CONSTRUCTION DOCUMENTS

FALCON MARKETPLACE

ISSUE	DATE
90% SUBMITTAL	5-6-19
REVISED	7-19-19
DESIGNED BY:	TDM
DRAWN BY:	KGV
CHECKED BY:	TDM
FILE NAME:	20988-CD-CVR

COVER SHEET

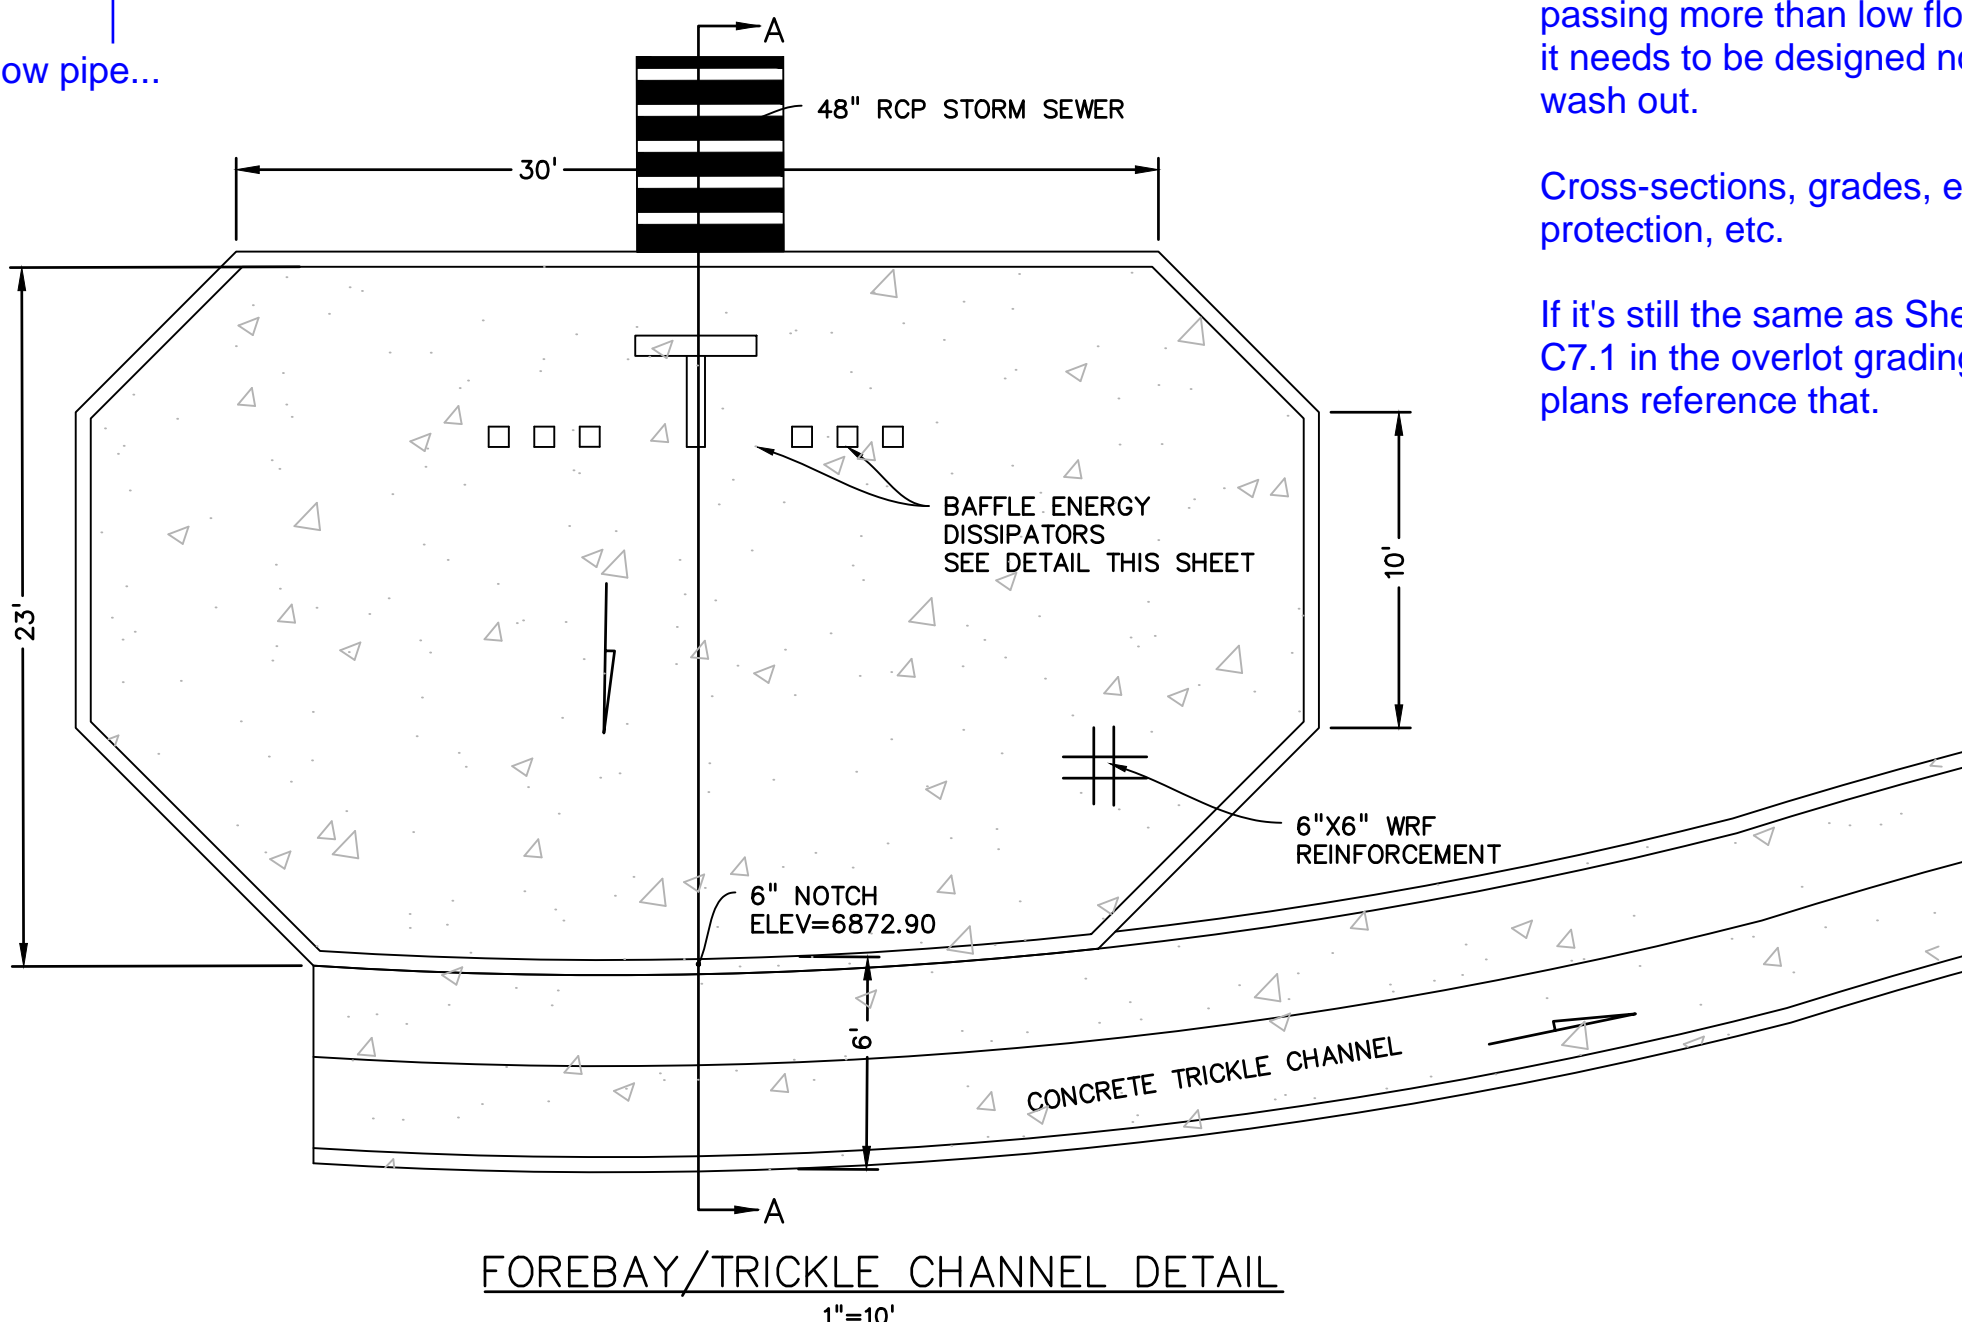
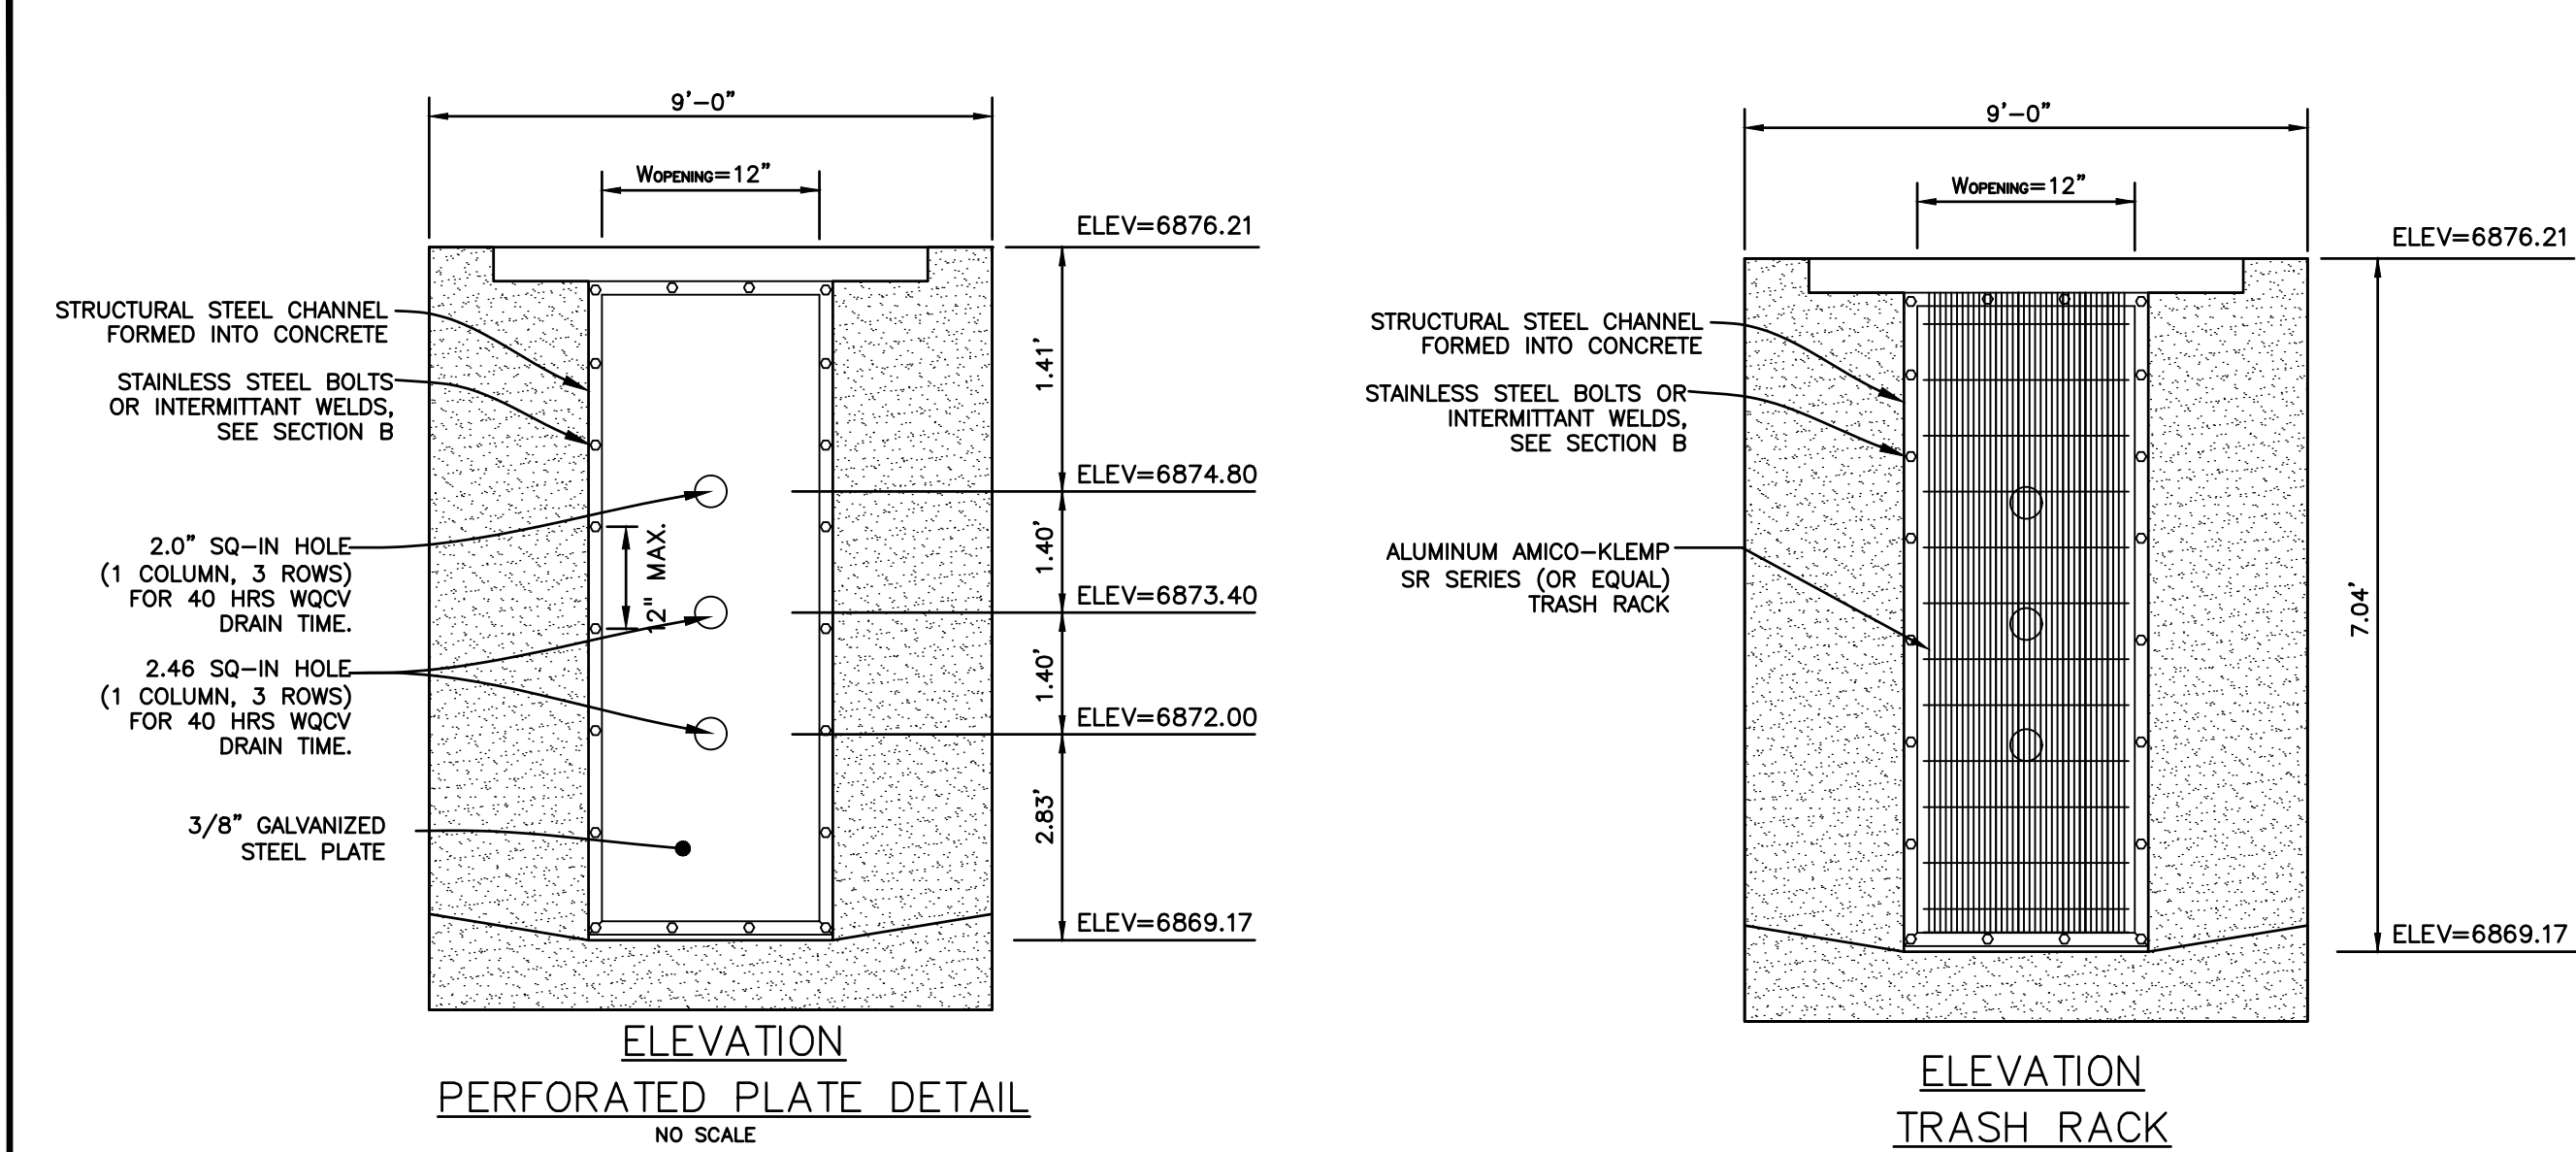
If it's still the same as Sheet C7.1 in the overlot grading plans reference that.
